FINAL REPORT
MECHANICAL-ELECTRICAL AUXILIARY BUILDING BASEMAT
SOUTH TEXAS PROJECT ELECTRIC GENERATING STATION UNIT 2

Unit 2 Mechanical Electrical Auxiliary
Building Base mat
Figure 1

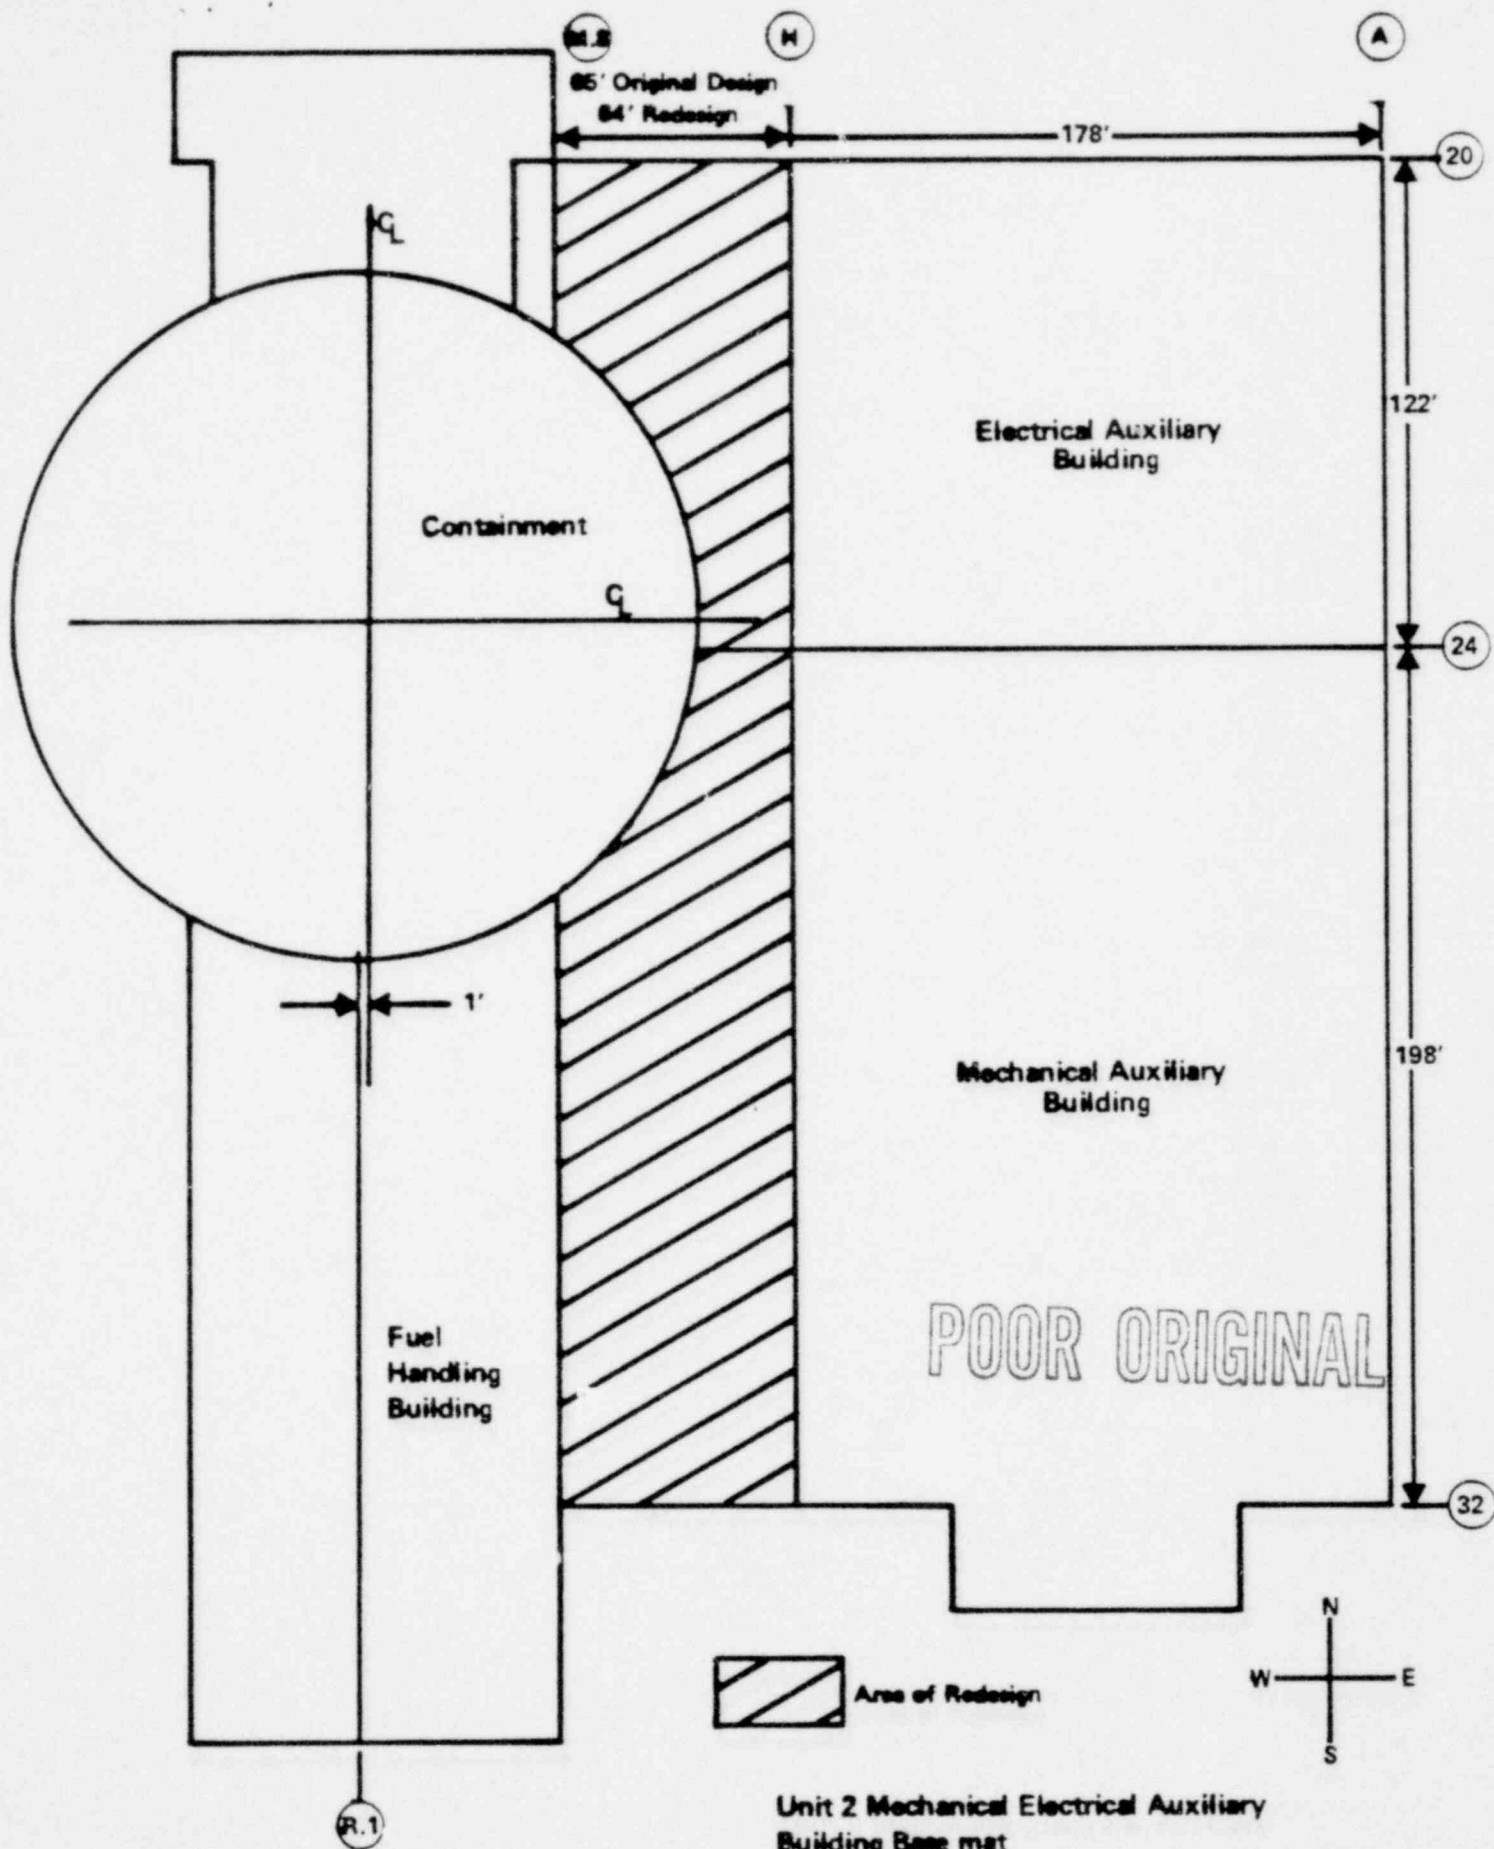
Due to a survey calculation error, the basemat of the Unit 2 Mechanical-Electrical Auxiliary Building was constructed one foot short on the east side of the building. The error occurred because, instead of using the containment/reactor centerline as the reference as had been intended, the building was laid out in the field using the dimensions relative to column line R.1 in the Fuel Handling Building. Column line R.1 in the Fuel Handling Building is offset one foot to the west of the containment/reactor centerline (see Figure 1) thus resulting in the east edge of the Mechanical-Electrical Auxiliary Building being laid out one foot short of the design. The survey calculations were not properly checked by the Field Engineering Supervision.

Redesign of the Mechanical-Electrical Auxiliary Building to compensate for the one foot dimensional error has resulted in only interior spatial alterations. From column line A to column line H (see Figure 1), the layout within the building is unchanged from the original design. From column line H to column line M.8 the one foot has been compensated by reducing distances between column lines and removing excess floor space around the layout of systems and equipment. The general arrangement of equipment within the redesigned area is unchanged by the one foot dimension. Approximately three-fourths of the building (column A to column line H) is unchanged from the original design and the redesign affected only the west one-fourth of the building.
